Re: Permit No. DRV12-00921

Reference: Permit No. DRV12-00921 Lake Street Place Design Review

LAKE STREET PLACE
112-150 LAKE STREET S
KIRKLAND, WA 98033

PERSPECTIVES

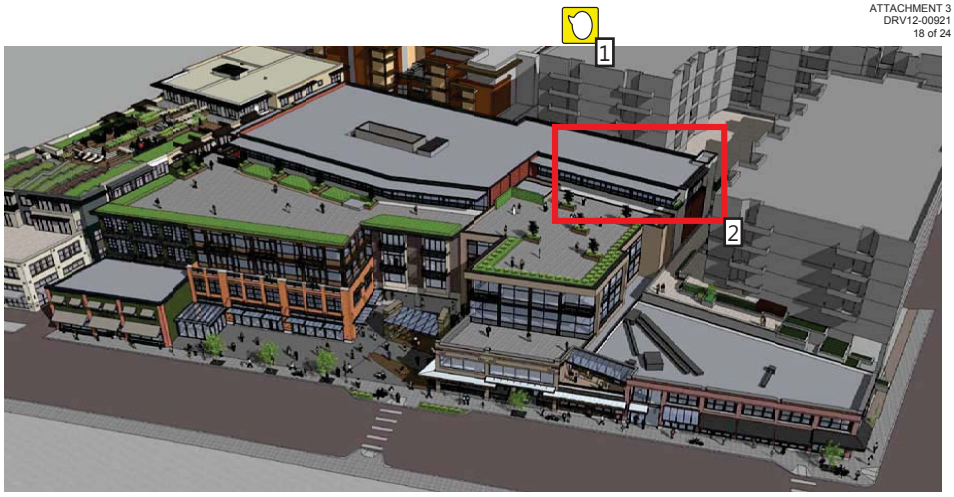
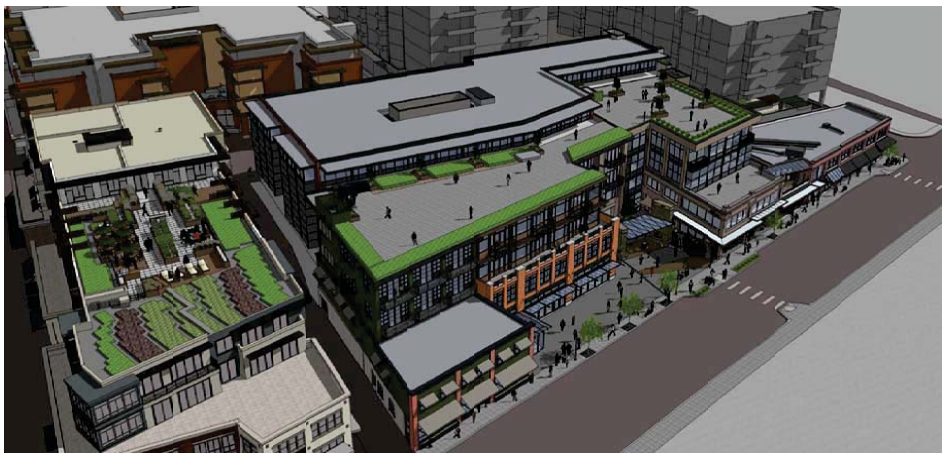
Number: 1 Author: czarnjil Subject: Sticky Note Date: 11/18/2012 5:05:13 PM -08'00'

Removing the 6th floor office space on the south end in front of the Portsmith common area would not box the residents of Portsmith in quite so much.
